April 13, 2018  
Serial: HNP-18-039

Shearon Harris Nuclear Power Plant, Unit 1  
Docket No. 50-400/Renewed License No. NPF-63

Subject: Supplement to License Amendment Request Regarding Spent Fuel Storage Pool  
Criticality Analyses

SUPPLEMENT TO LICENSE AMENDMENT REQUEST REGARDING SPENT FUEL  
STORAGE POOL CRITICALITY ANALYSES

Figure 2.1: DREAM™ INSERT

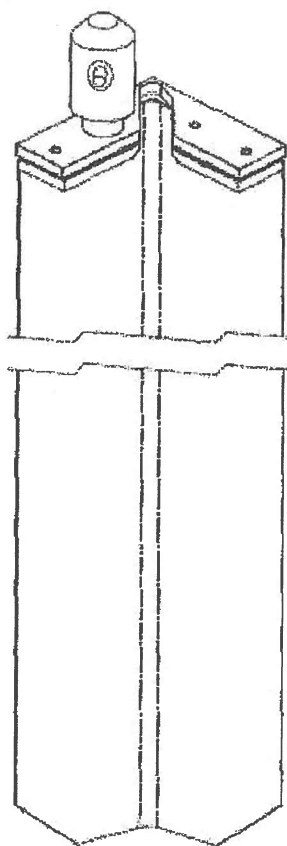
Revision 2 – This report is being revised to update the chapter 2 with the latest figure of the insert. The insert design was slightly modified to increase the gap between the steel plates (in the top portion of the insert) and to modify the lead-ins on the steel plates. A chamfer was also introduced on a small portion of Metamic at the bottom of the insert (non-active fuel region). All changes described above were made to improve installation and to avoid interference issues. Chapter 6 was revised to update the revision number of the insert calculation package (revised to update the ASTM spec change from B209 to B221 for the support block and insert block attachment). Chapter 3 was revised to remove certain shaded portions of the text which are publicly available. All changes are marked by revision bars.
